VIRGINIA ELECTRIC AND POWER COMPANY
RICHMOND, VIRGINIA 23261

VIRGINIA ELECTRIC AND POWER COMPANY
SURRY AND NORTH ANNA POWER STATIONS UNITS 1 AND 2
OPERATIONAL QUALITY ASSURANCE PROGRAM
NUCLEAR OVERSIGHT BOARD (NOB) DELETION

Discussion of Change

Figure 17.2.1-1
 OFFSITE NUCLEAR ORGANIZATION

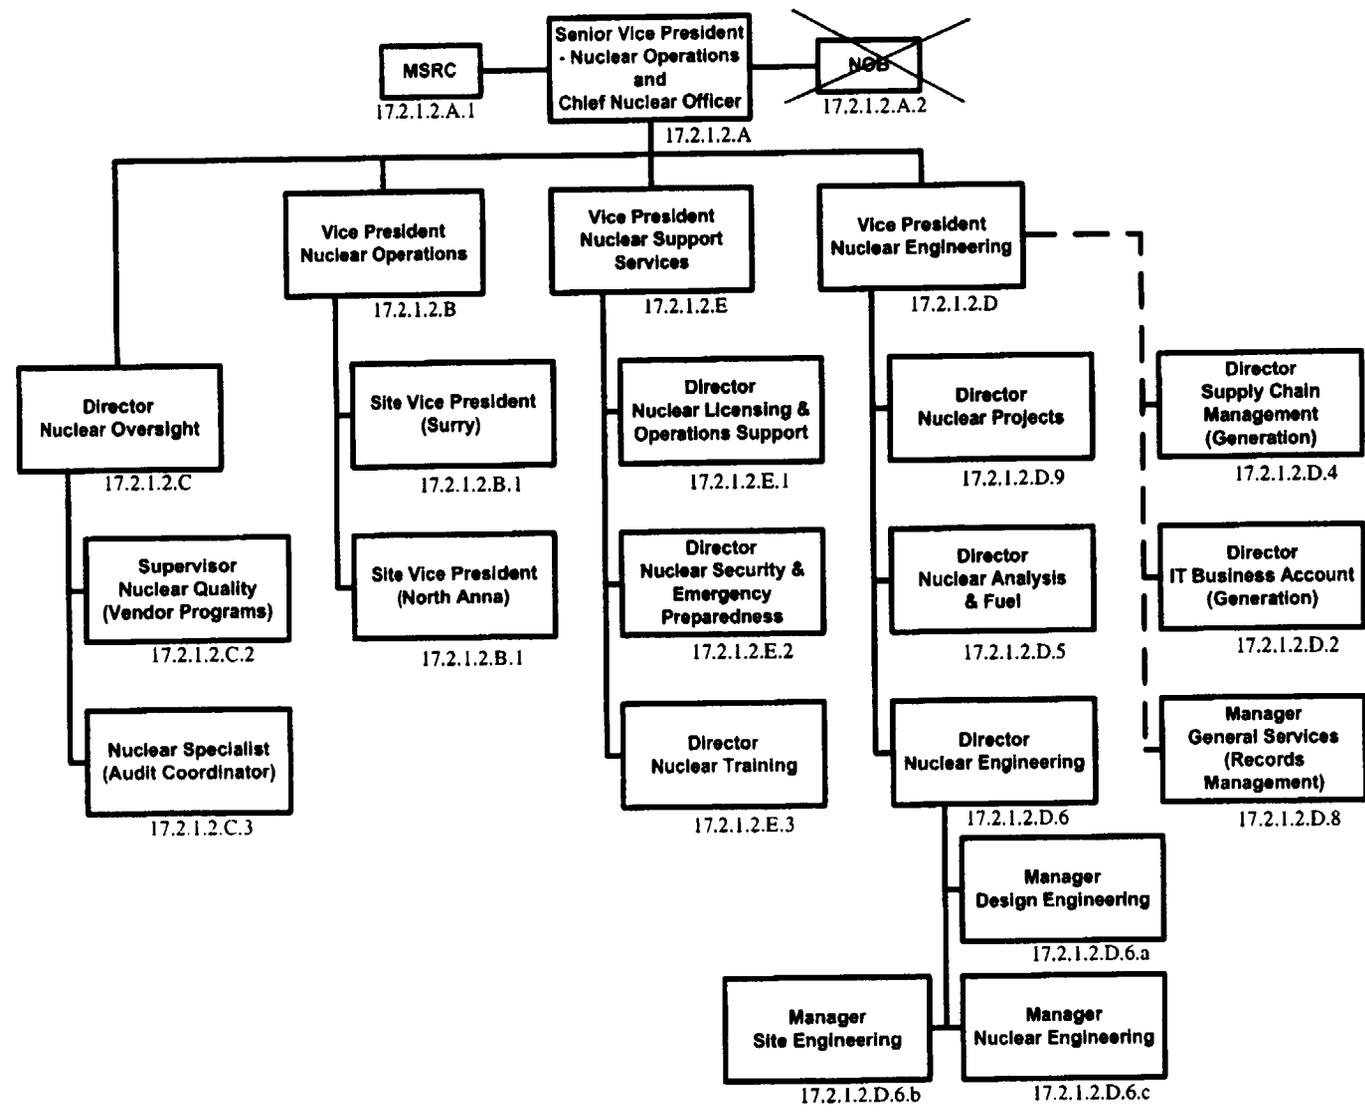
The QA Topical Report is being revised to delete the description of and reference to the Nuclear Oversight Board (NOB) from the UFSAR Section 17.2.1, Organization. Specifically, Subsection 17.2.1.2.A.2, Nuclear Oversight Board (NOB) and reference to the NOB in Figure 17.2.1-1, Offsite Nuclear Organization, is being deleted.
